LONGWOOD PLACE

SUBMISSION TO BOSTON CIVIC DESIGN COMMISSION
APRIL 3, 2026

Summary of BCDC Feedback: Landscape

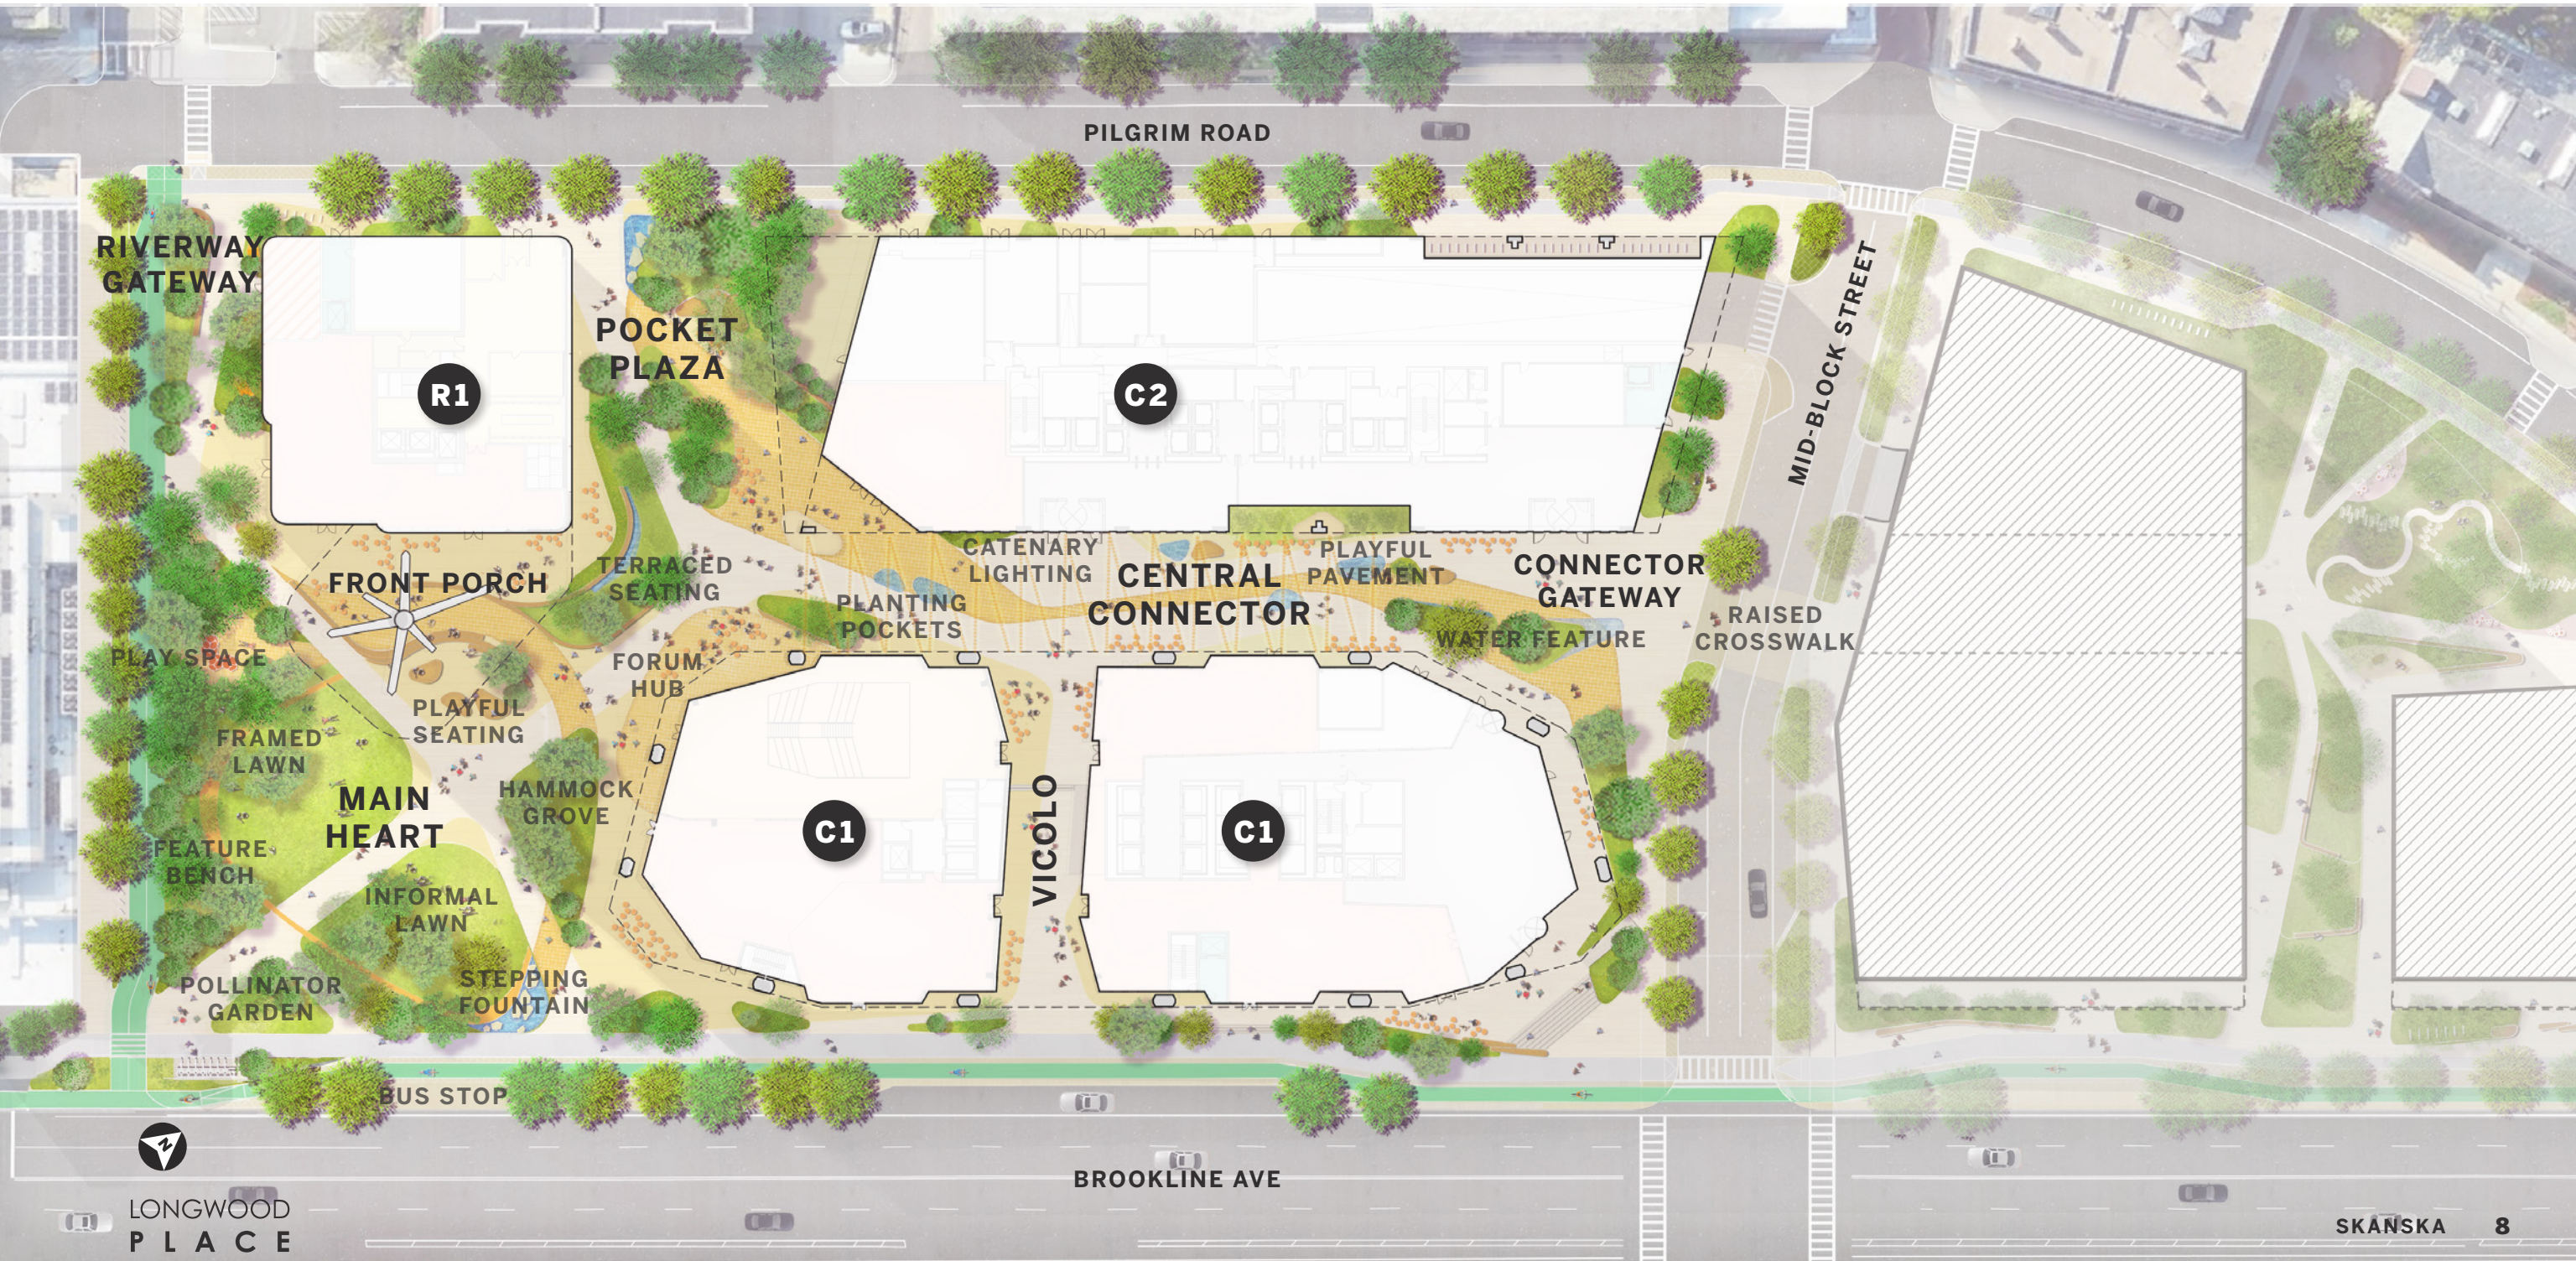
1. Landscape concept: Make the Heart more cohesive in terms of program scale.
2. Consolidate: There is a desire for the Heart to be a larger expansive space.
3. Distribute: Expand vitality of the Heart with proportional elements distributed across the site.
4. Highlight how the landscape changes from Park vs. Urban while carrying similar design identity.
5. Add more green (planted) spaces when possible.
6. Introduce a sense of discovery.

1. The landscape design shows a unified "ensemble" and a functional "park" rather than fragmented pieces.
2. The landscape acts as the "carpet" integrating all buildings, though the central connector needs simpler circulation and review regarding seating areas and water features.
3. There is a need to further study the Front Porch how the main column lands to ensure pedestrian clarity and avoid the need for railings for cane detection safety.
4. Show the topographic strategies that can be implemented in the Heart to illustrate level variations within the landscape, to create and define spaces.
5. Status: Formally recommended for approval by the Commission.

Summary of BCDC Feedback: R1

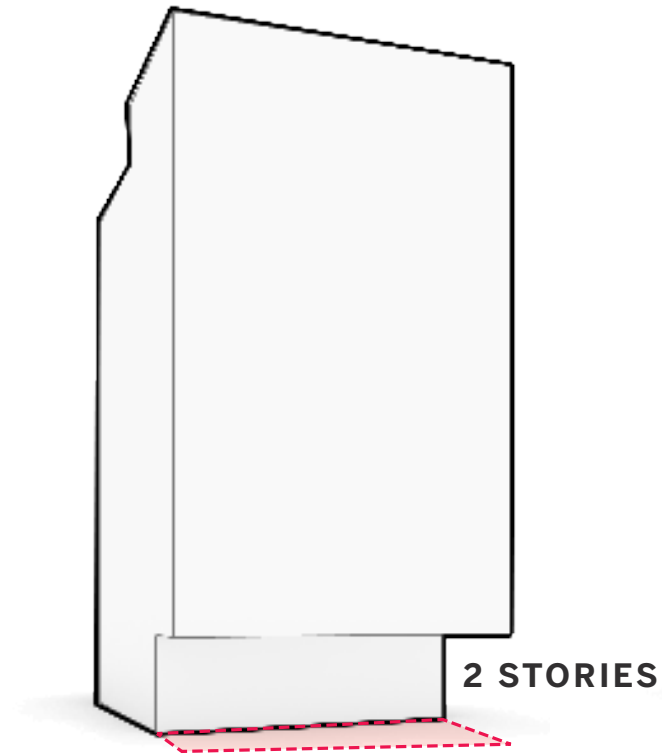
1. Commissioners generally considered the parti successful.
2. The lightness and column were successful to some, while others suggest the tower could feel lighter.
3. The cornice at the base of the lifted tower could be ultra-thin to enhance the lightness.
4. The column was viewed as interesting but possibly confusing and distracting.
5. The team should explain how the column sits within the landscape.
6. The single-story portion of the base feels “unclaimed” by the parti.

7. Examine the front porch as a holistic narrative and address the R1 facade:
 - Height of glazing elements.
 - Amount of red brick.

R1 View from Brookline Avenue (BCDC May 2025)

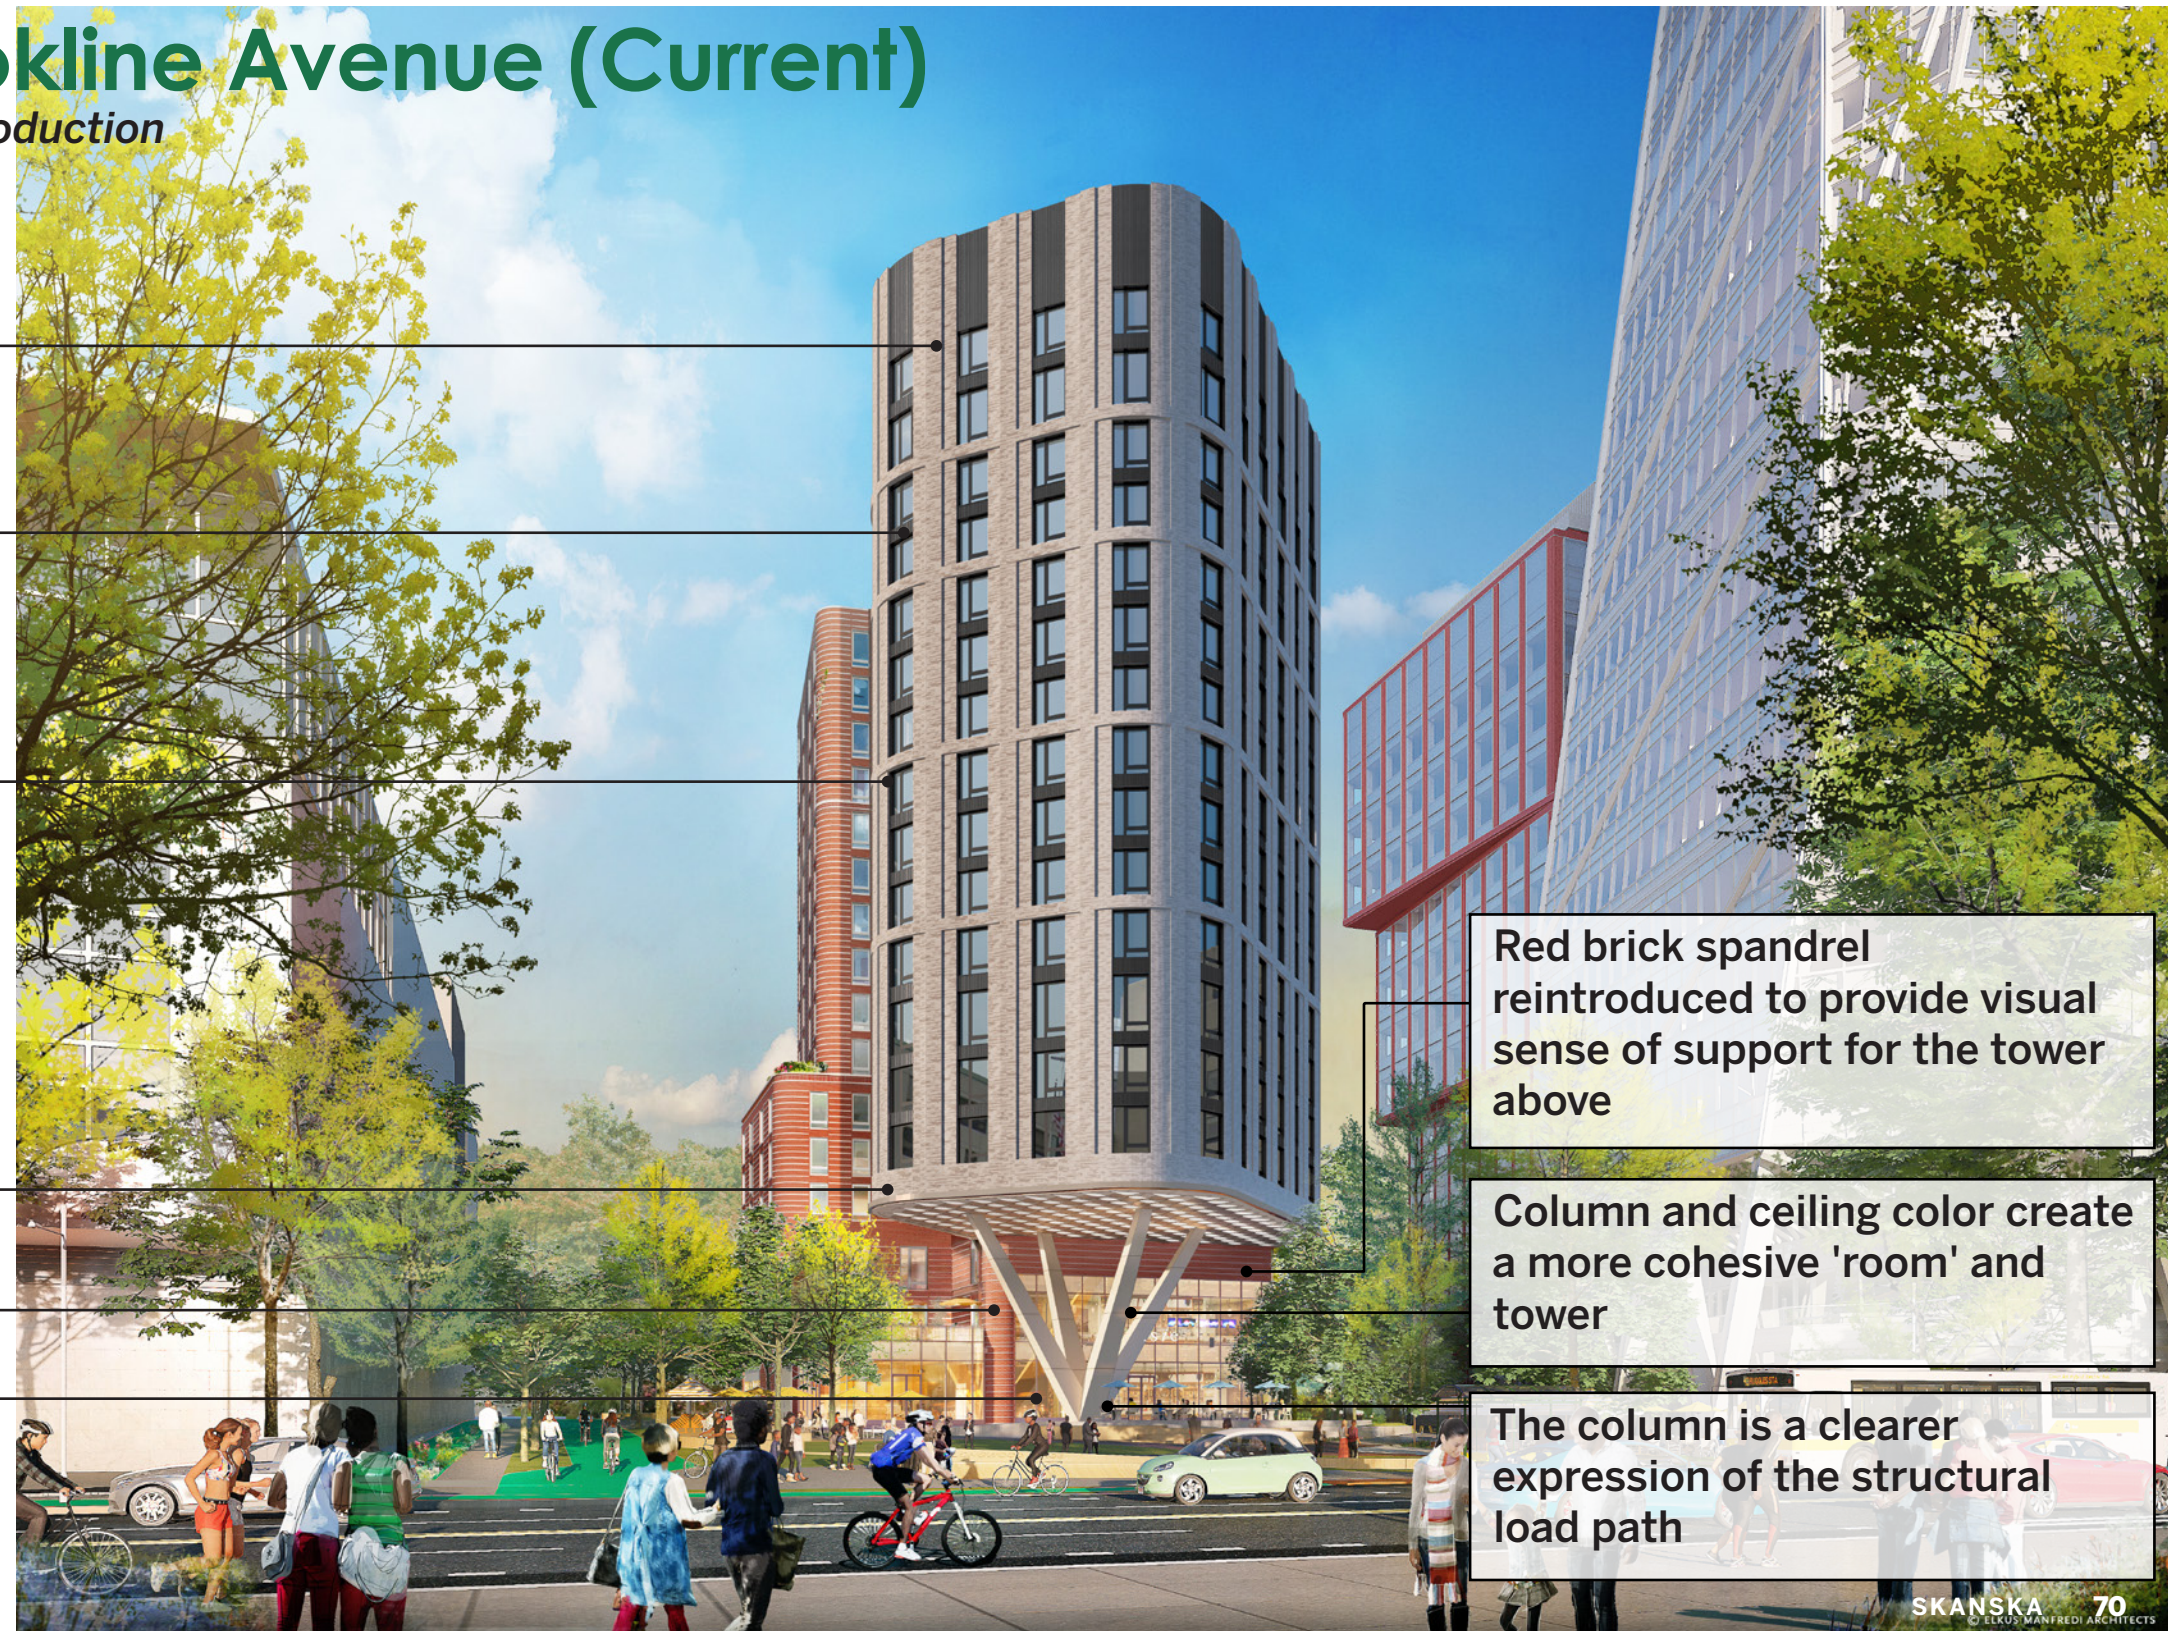
Create a 'lighter' tower

Reduce profile of bottom band

Study this single story retail element

Ensure the Front Porch is cohesive, avoid competing architectural elements

Study the column and the ceiling and landscape of the Front Porch

Thinner, more defined piers to create greater depth and shadow

Darker metal to create more contrast and a taller, 'lighter' expression

Reorganized window groupings better align with horizontal datum of the ensemble

Bottom band is thinner and lighter in color

Red brick pier is stronger, to clarify the parti

The R1 facade at the front porch is refined, with fewer competing elements.

Red brick spandrel reintroduced to provide visual sense of support for the tower above

Column and ceiling color create a more cohesive 'room' and tower

The column is a clearer expression of the structural load path
